Our Ref: 87052-CUR-XX-XX-T-TP-00003-P02

Re: 25/00617/FUL – Land at Halsnead Farm, Fox's Bank Lane, Whiston & Cronton, L35 3SU
Post Submission Technical Note 01

Thank you for providing Knowsley Council's (KC) Highway Observations Memo (included at **Appendix A**), dated 10th February 2026, in relation to the above application.

Figure 1 – Existing TROs Fox's Bank Lane

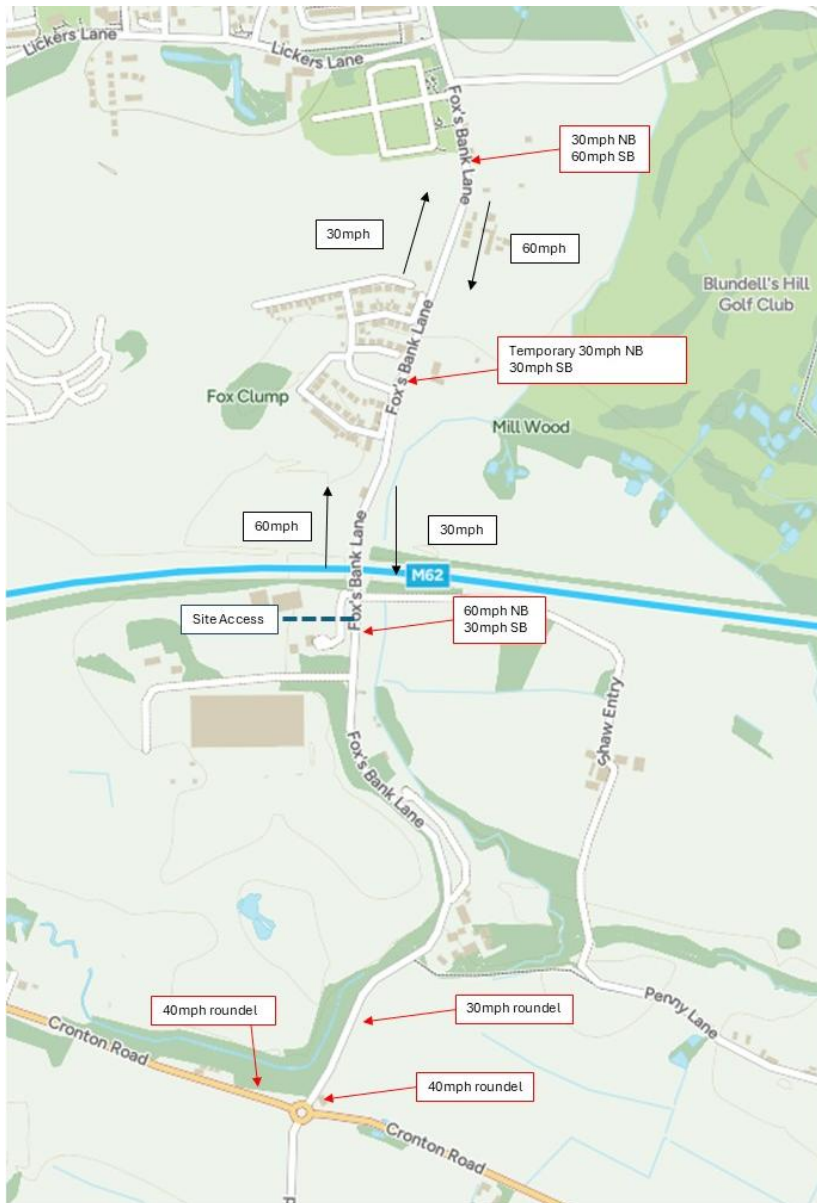
Several comments are provided with regards to the visibility at the proposed site access arrangement. These are predominantly linked to the current speed environment along Fox's Bank Lane.

Following KC's response, Curtins has been out on site to review the latest Traffic Regulation Orders (TROs) on Fox's Bank Lane in vicinity of the site. These are illustrated on **Figure 1** overleaf and a series of site photographs are also provided in **Appendix B**.

As demonstrated on **Figure 1** the current signage results in situations whereby two different speed limits are applied directionally on the same sections of single carriageway. For example, past the site access, the current signage states 60mph northbound whilst southbound vehicles are signed to 30mph from the Fox Wood Garden Village traffic signals. A similar situation occurs to the north of Fox Wood Garden Village. It is Curtins view that these are atypical and confused arrangements (with two different speed limits on the same section of single carriageway).

Whilst it is acknowledged that the TRO process sits independently to planning, it is considered that the existing TROs require amendment regardless of whether the proposed development comes forward or not, for the following two reasons:

Figure 3 – Masterplan Connectivity.

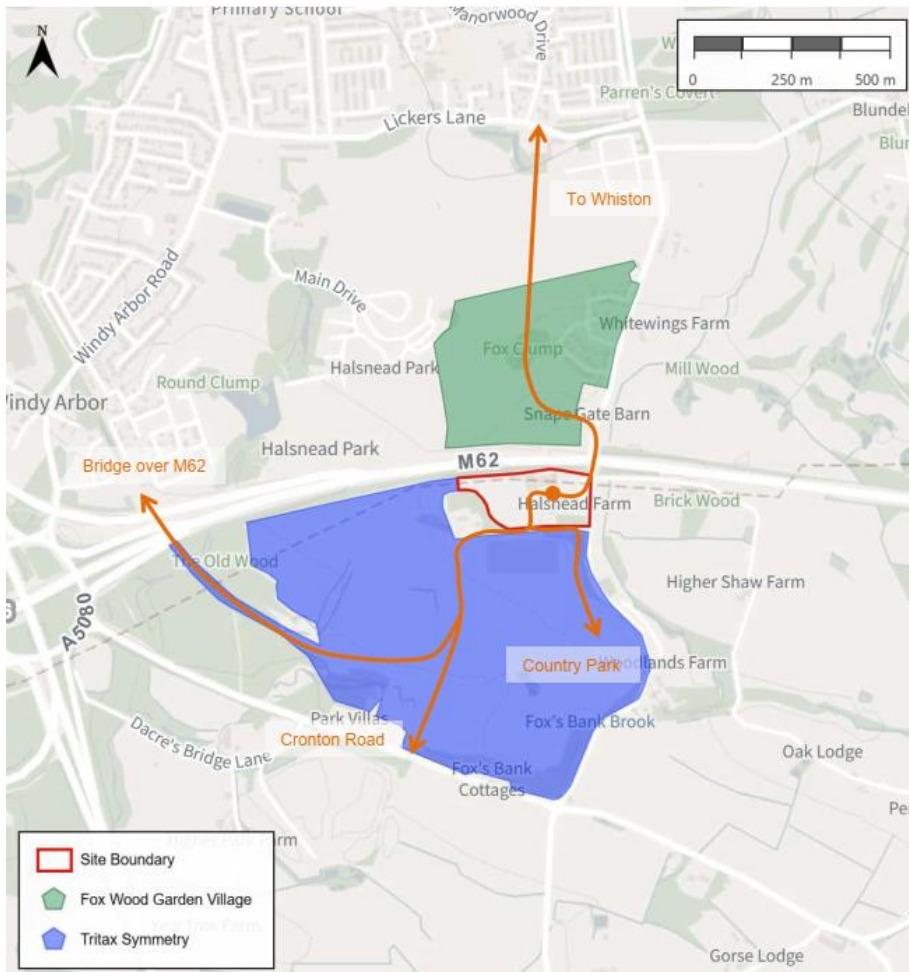
The proposed footway connection along the frontage of the site at Foxs Bank Lane is positive in principle, but beyond the site frontage there are significant constraints, particularly when approaching the motorway bridge to the north, where the existing footway narrows and no widening works are proposed. To the south, the footway provision becomes inconsistent and narrows as it moves away from the site access. These limitations significantly reduce the attractiveness and perceived safety of walking beyond the immediate site frontage.

To the south, the potential connections through the Tritax employment site and onward to the consented Country Park are not deliverable at present. The Tritax site is private land, with no public rights of access for pedestrians or cyclists, and no outstanding s106 obligations requiring delivery of the active travel link shown on local policy mapping. Although the Country Park benefits from planning permission, there is no evidence of construction or any confirmed delivery timetable. As such neither of these routes can be considered available, safe or guaranteed for sustainable travel.

As set out in detail within the TA, the various allocated sites are reliant on one-another to deliver the wider Masterplan accessibility. This is illustrated in the below **Figure 3** (an extract of Figure 4.1 of the TA).

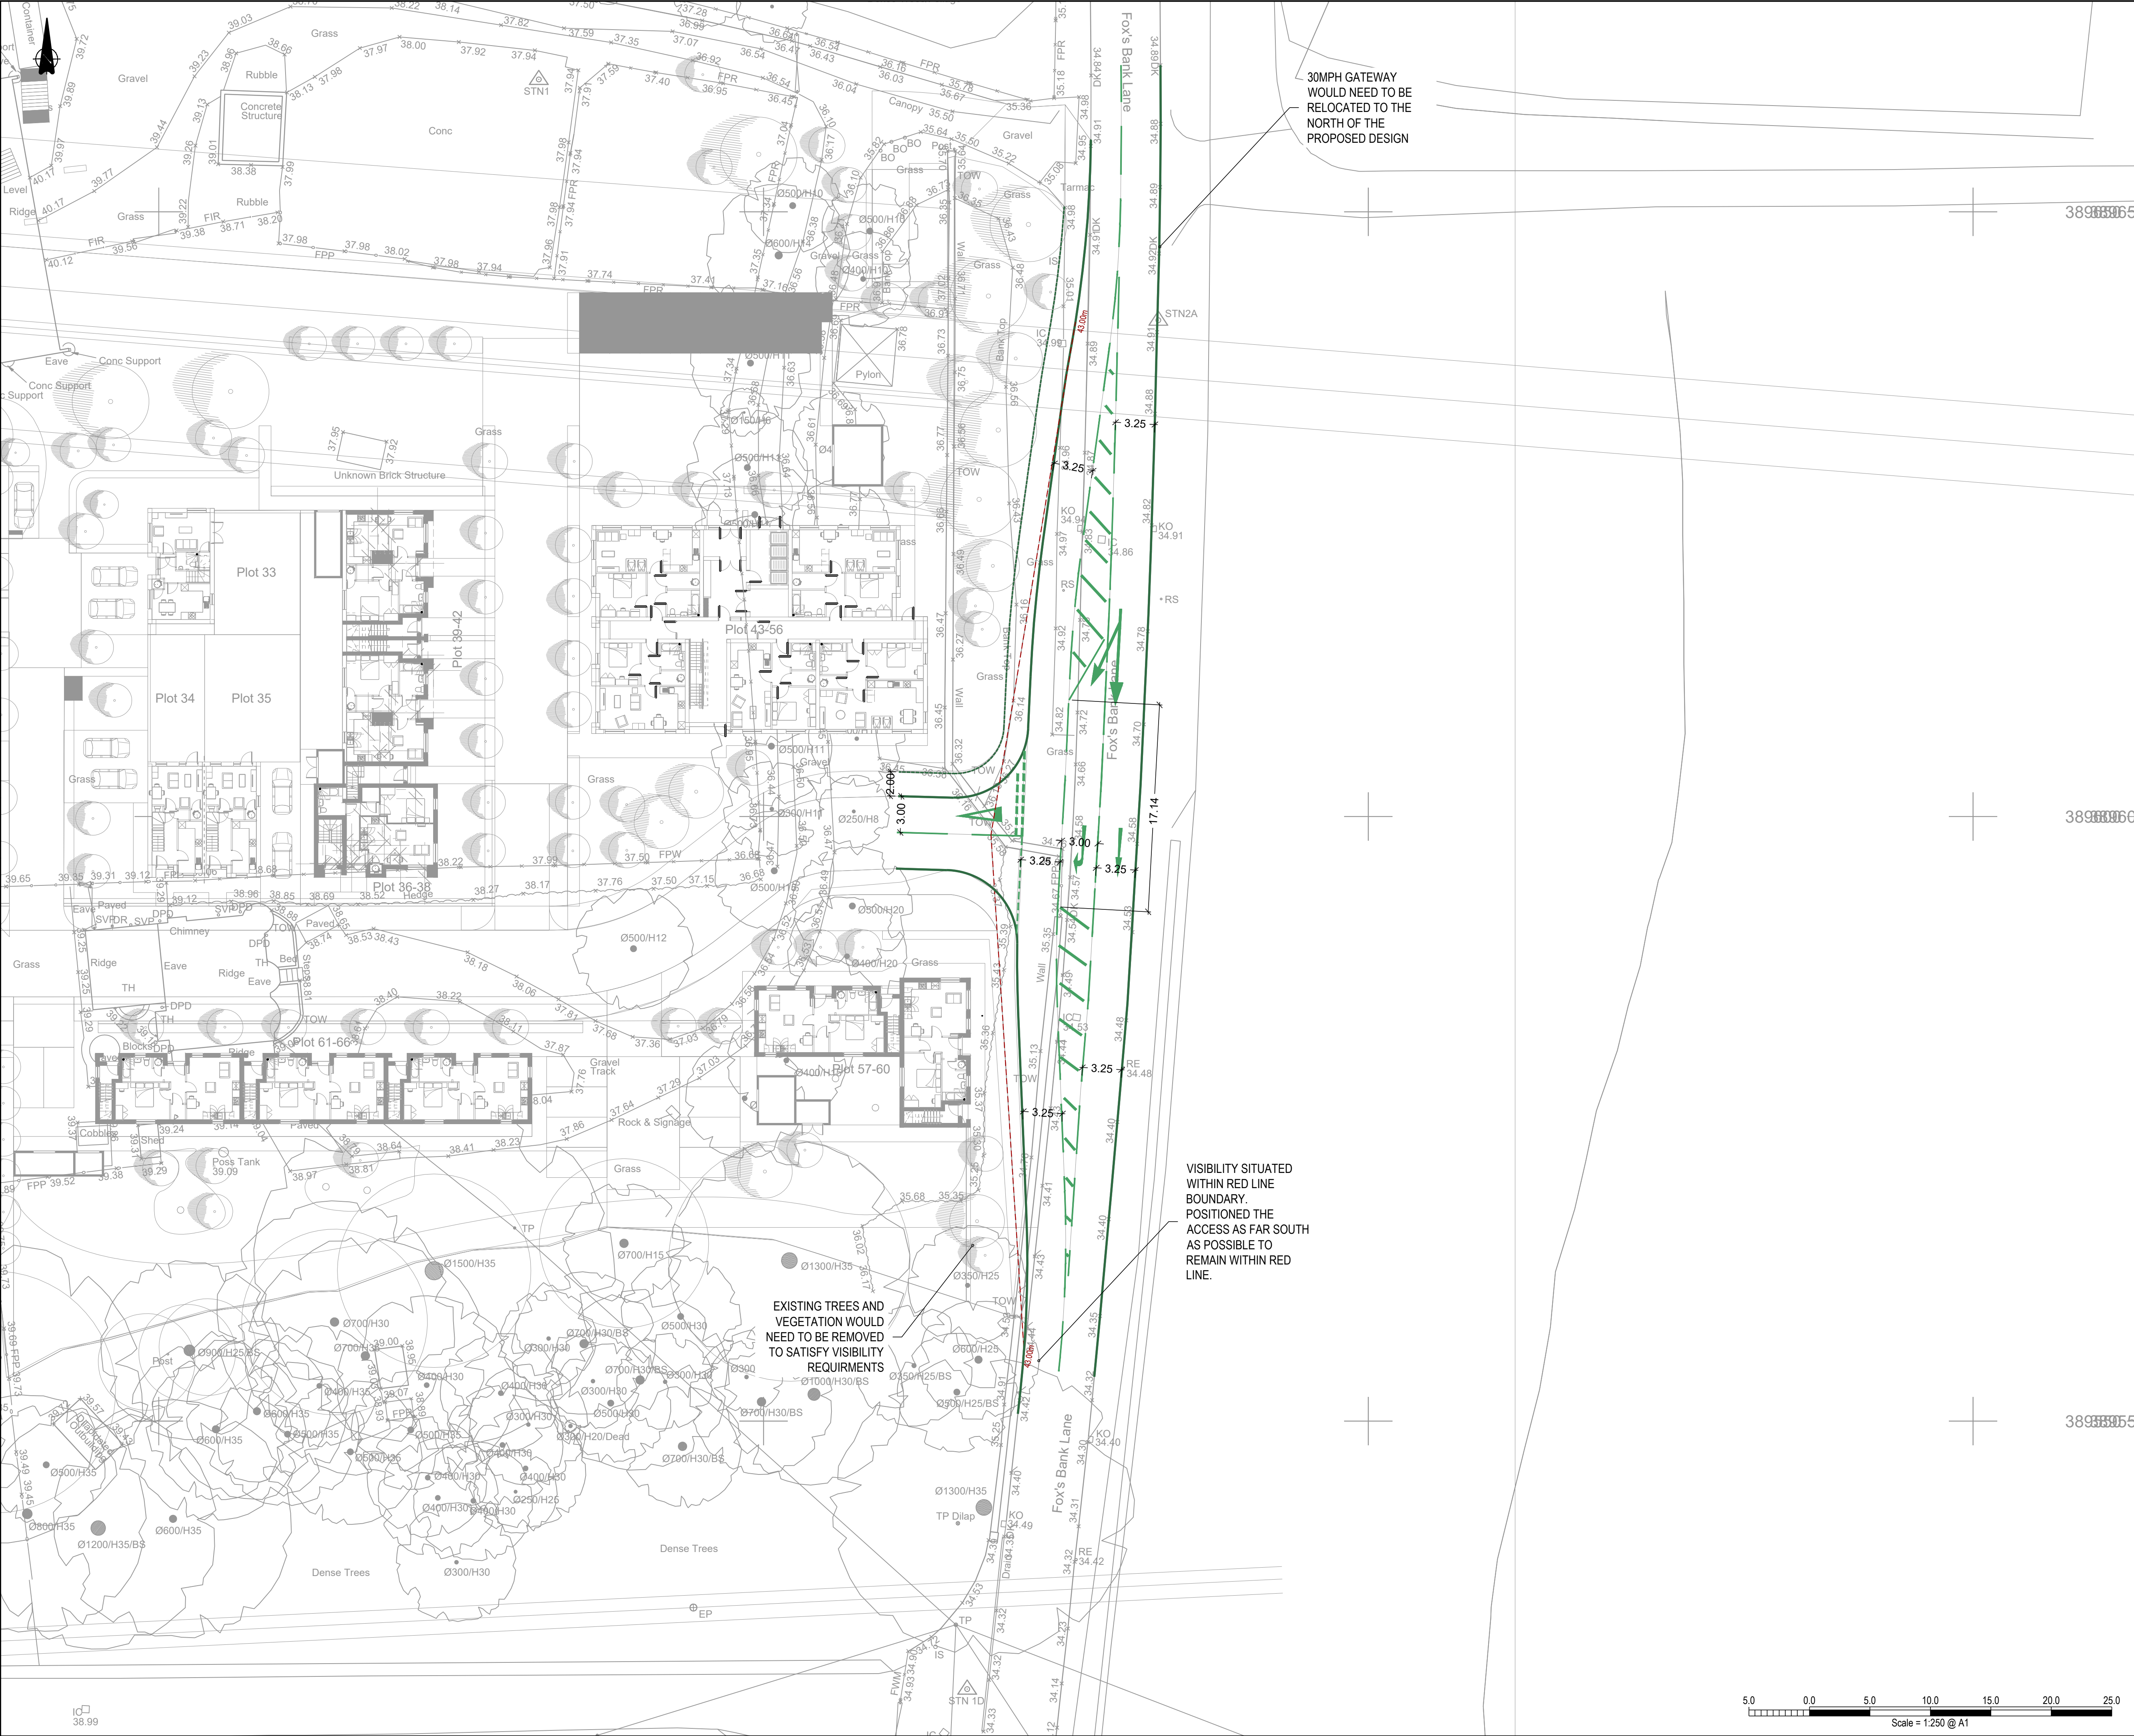
Notwithstanding the apparent geometric feasibility, the TA includes no assessment of right-turn queue length or storage adequacy. The modelling undertaken relates solely to priority-junction capacity at the give-way line and does not assess the operational performance of the right-turn lane itself. The applicant is therefore required to provide evidence-based confirmation that the proposed right-turn facility offers sufficient stacking capacity to accommodate forecast AM and PM peak demand. This assessment must be based on the directional flows presented in the TA's trip distribution and assignment and must be accompanied by a fully dimensioned GIRT layout, confirming:

- *entry taper length*
- *right-turn storage length*
- *exit taper length*
- *ghost-island width*
- *residual running-lane widths*

In addition, the submitted drawing contains departures relating to signing and lining (including arrow placement and hatch-marking arrangements) which must be corrected to meet current TSRGD and Traffic Signs Manual requirements. Accordingly, while the concept is supported in principle, the detailed geometric design of the GIRT will require full review and approval under a Section 278 agreement; the granting of planning permission should not be interpreted as confirmation that the submitted layout is acceptable for construction.

The submitted plans show indicative footways within the development, including a proposed new footway along the western side of Fox's Bank Lane fronting the site. However, the plans do not clearly annotate footway widths, tactile paving, or adoptable extents.

Dimensions have been added to the site access drawing as requested. The updated drawing is presented as **Curtins Drawing 087052-CUR-XX-XX-D-T-75004** to the rear of this letter.

These comments are duly noted, and it is considered that the site access proposals will be subject to Section 278 agreement and detailed design process due course.

The proposed site access drawing (**Curtins Drawing 087052-CUR-XX-XX-D-T-75004**) demonstrates that visibility splays in accordance with a 30mph speed environment can be readily achieved.

Dimensions have been added to the proposed footway provision on Fox's Bank Lane (2m), this is shown on **Curtins Drawing 087052-CUR-XX-XX-D-T-75004**. These works are deliverable within the adopted highway and land under control of the applicant. Once constructed it is envisaged that the footway would be adopted and maintained by KC.
